Gatwick Northern Runway Project DCO (Project Reference: TR020005)

Deadline 3 Submission (19 April 2024)

Crawley Borough Council (IP Ref: GATW-AFP107), West Sussex County Council (IP Ref: 20044715), Horsham District Council (IP Ref: 20044739) and Mid Sussex District Council (IP Ref: 20044737)

Figure 1: Relationship between Annual ATMs and declared 17 hour runway movement capacity² at Gatwick

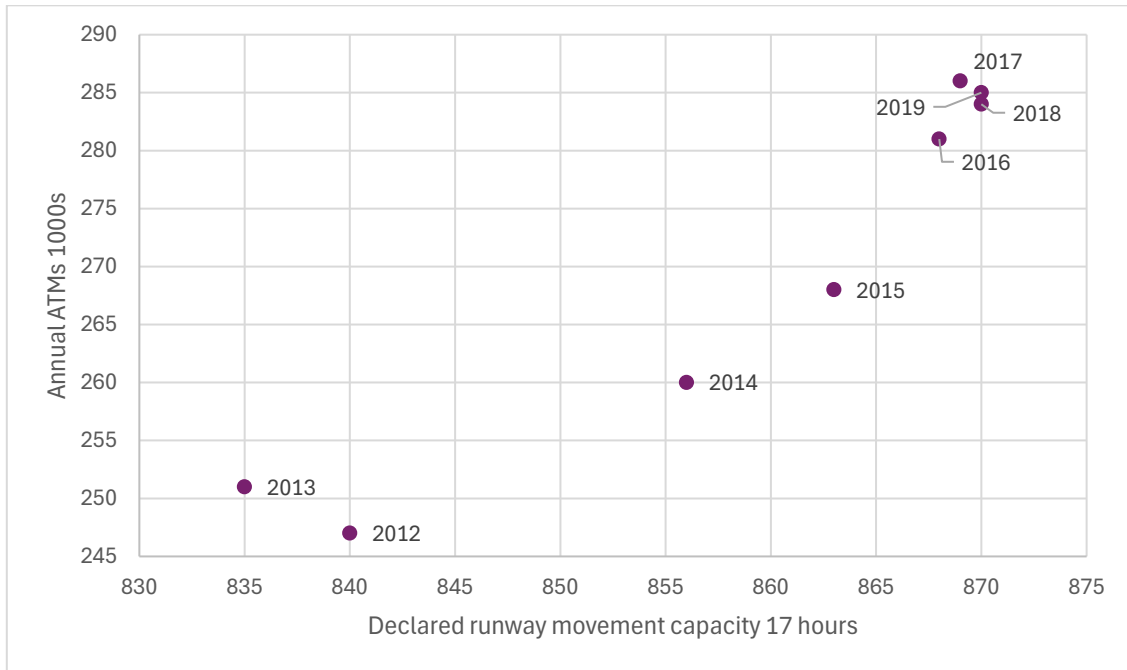
6. Although there is some evidence historically of growth through peak spreading in terms of an increase in activity in the winter months (Figure 3), growth appears to have been more closely related to increases in declared runway movement capacity. These increases appear to have largely stalled since 2016, potentially reflecting the risk of increased delays from any further intensification in the number of movements on any given day. This is illustrated in **Figure 1** below.

Figure 4: Demand and Capacity in the London Airport System with Gatwick NRP only

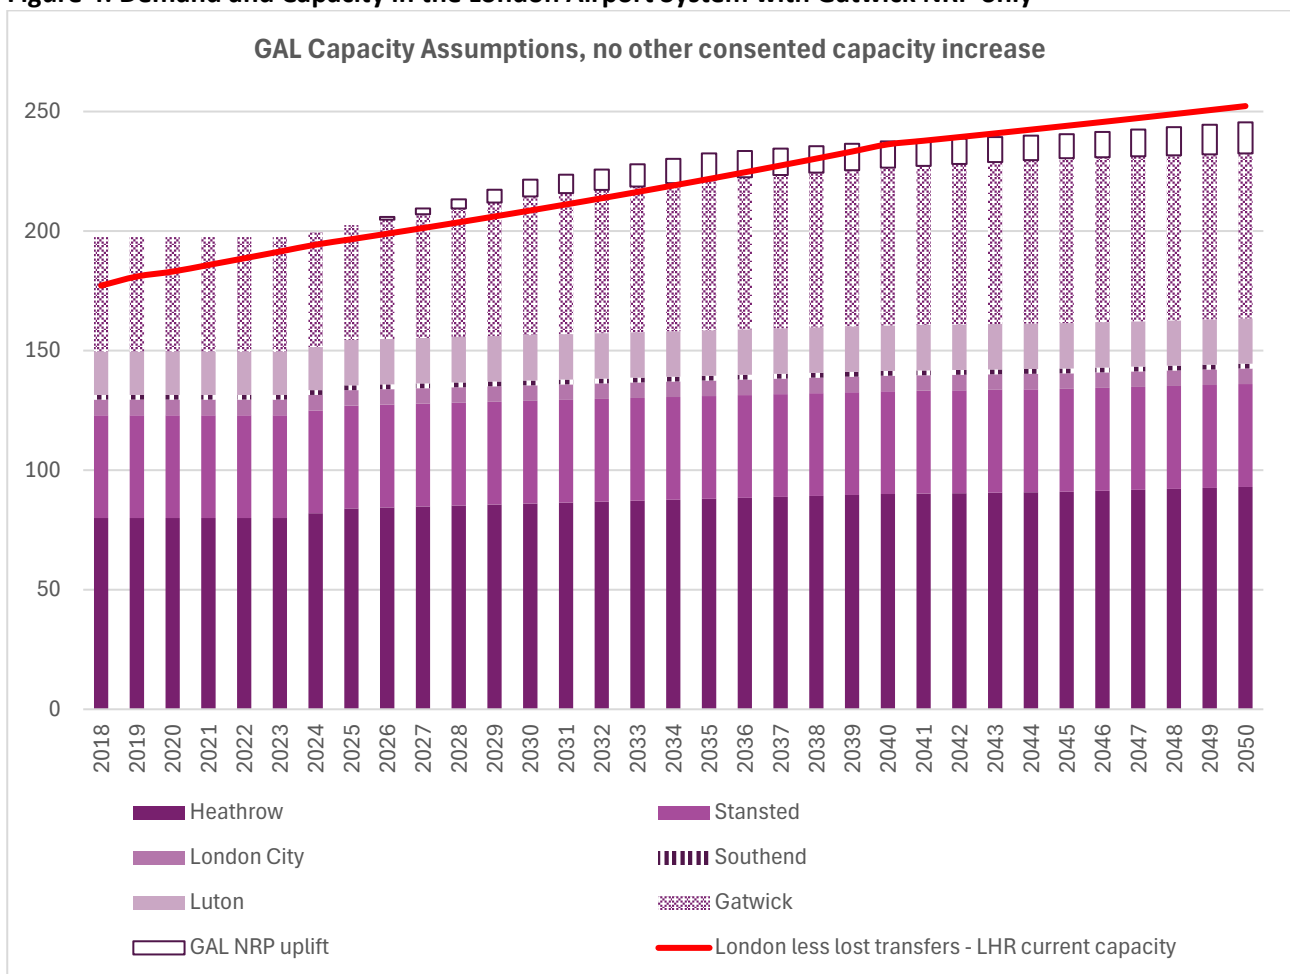
34. Having noted the apparent discrepancies in the data used and, whilst it is not apparent how the estimate of the net scale of the London unconstrained demand has been estimated by GAL from the explanation provided in the paper, our estimate of the scale of the market after having allowed for the loss of some transfer passengers from Heathrow that would not be replicated elsewhere is similar to that shown in Figures 43 and 47 – see **Figure 4** below, albeit this is before accounting for any fare related demand suppression at the individual airport level and without accounting for clawback of demand by regional airports. For the purpose of this chart, we have assumed that the capacity deliverable in the Baseline and NRP cases is as stated by GAL, notwithstanding our reservations as to the achievability of the full levels of throughput claimed.

35. The principal concern remains that GAL has put forward a case that simply assumes no additional capacity is provided in the London system over the period to 2050, other than that already consented

Figure 5: Demand and Capacity in the London Airport System with Gatwick NRP and Growth at Luton and London City

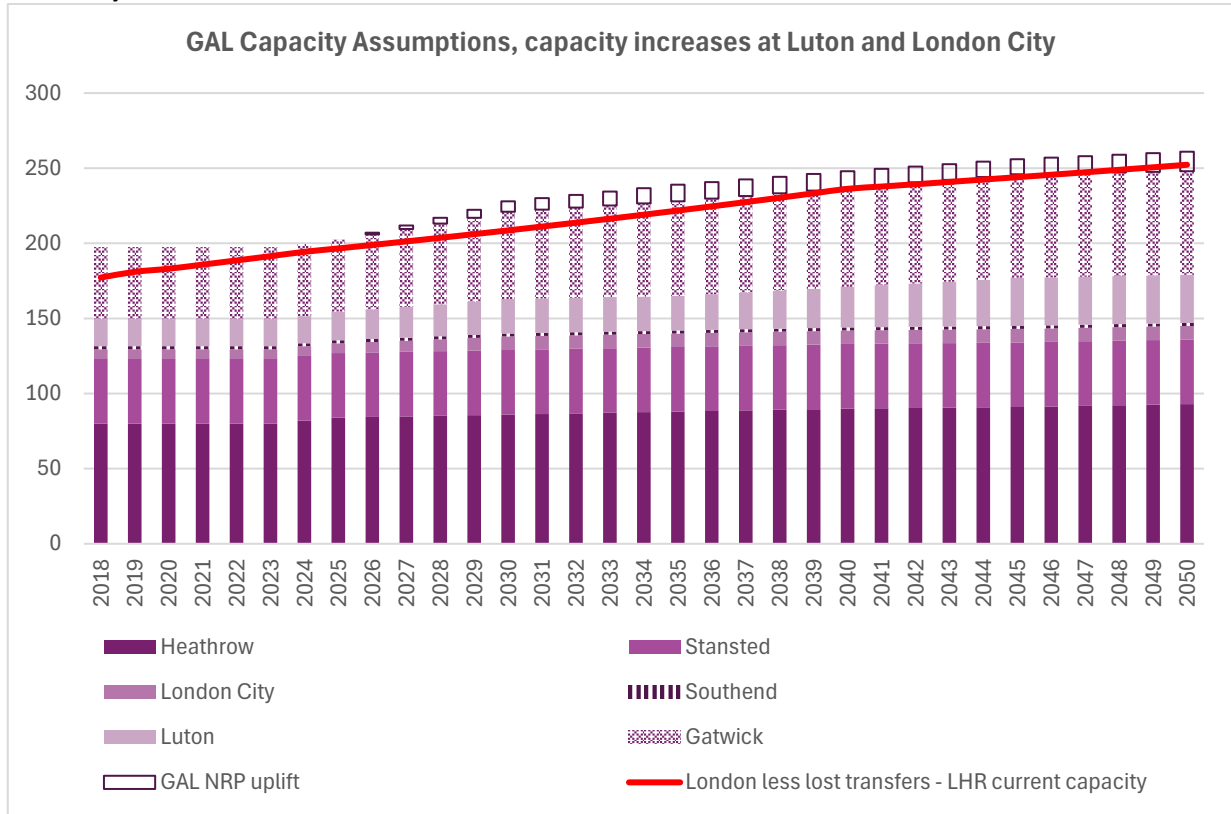
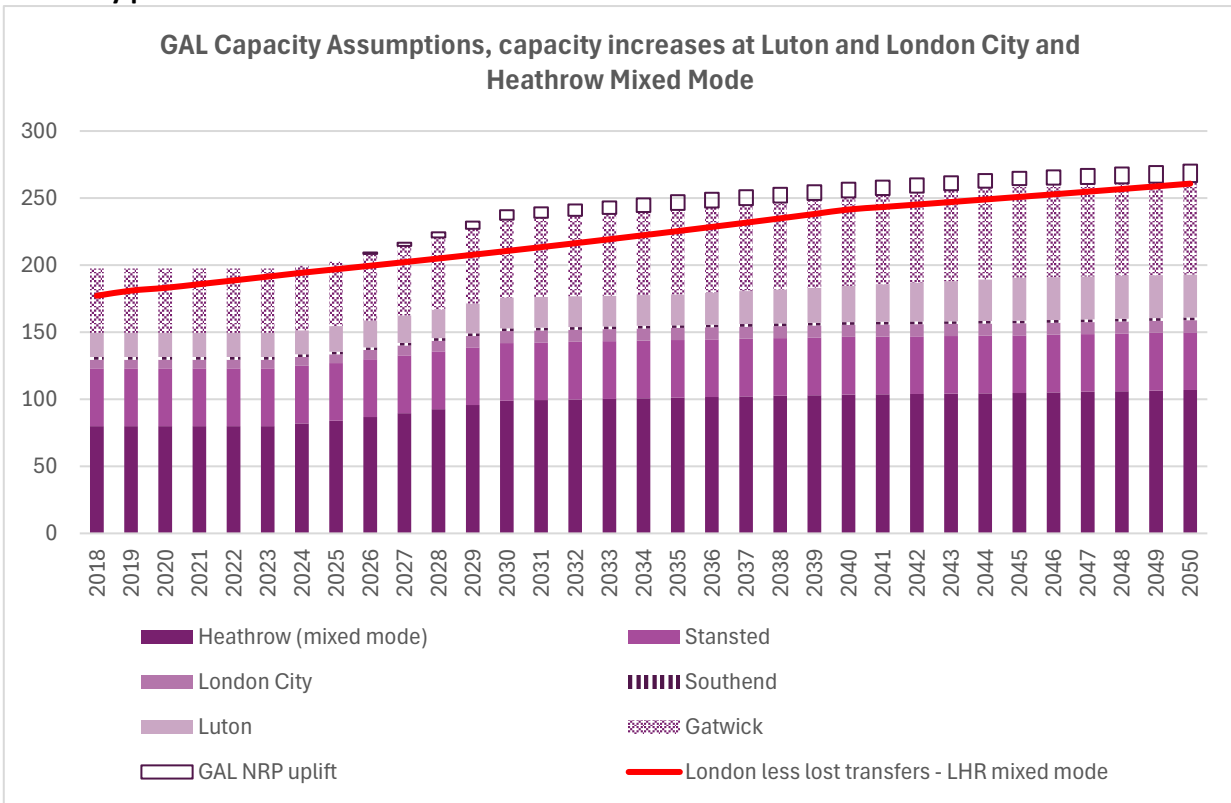
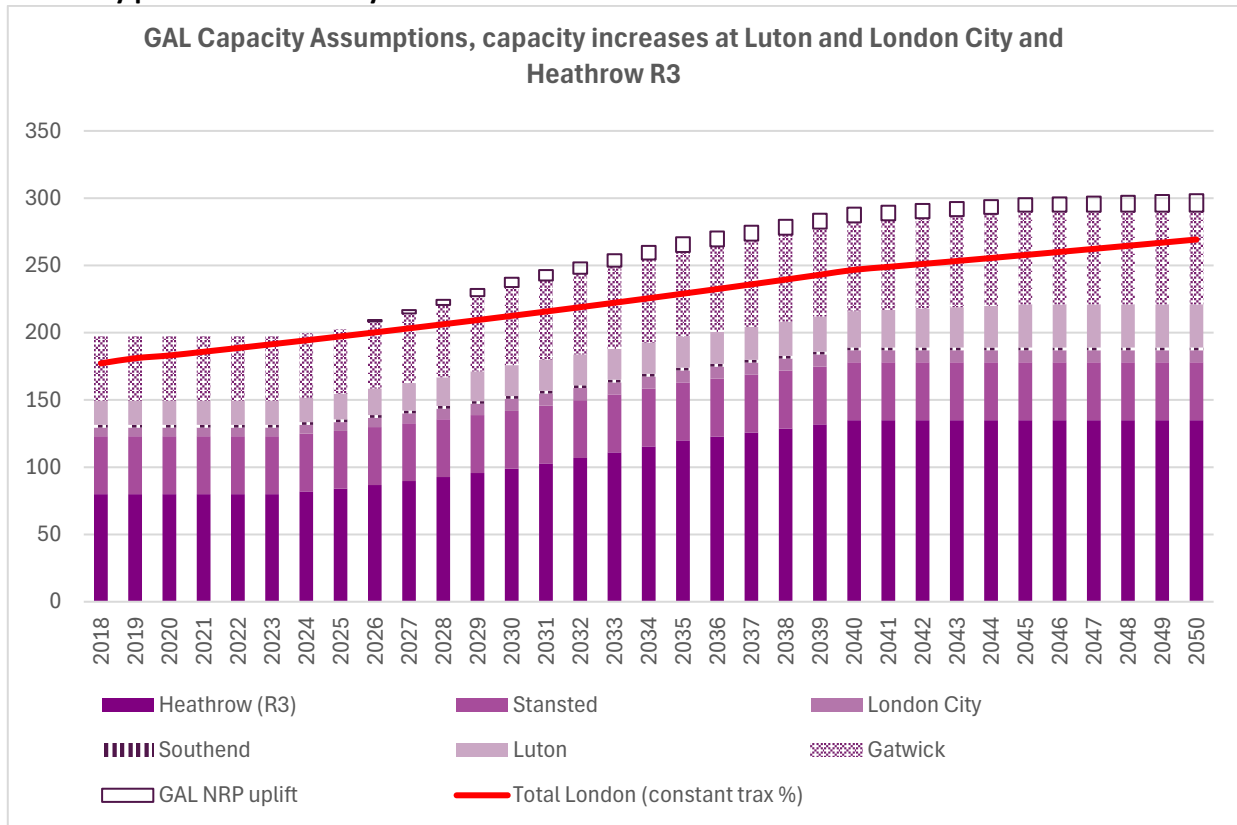
39. We illustrate in **Figures 5, 6 and 7** the demand capacity balance if other potential increases in airport capacity are approved, including at Luton, London City and Heathrow Airports. We have illustrated both an increase with mixed mode at Heathrow, assumed to add 15% to capacity, and a full third runway.

40. The above charts illustrate how sensitive the level of demand for Gatwick is likely to be, dependent on the capacity provided elsewhere. At the very least, these considerations highlight a real risk that Gatwick will not achieve the rate and, potentially, level of overall growth in demand projected to use the Airport over the period to 2047 with the NRP in place. This has implications for the assessment of impacts and the controls that would need to be put in place at different points in time, including but not solely the Noise Envelope.
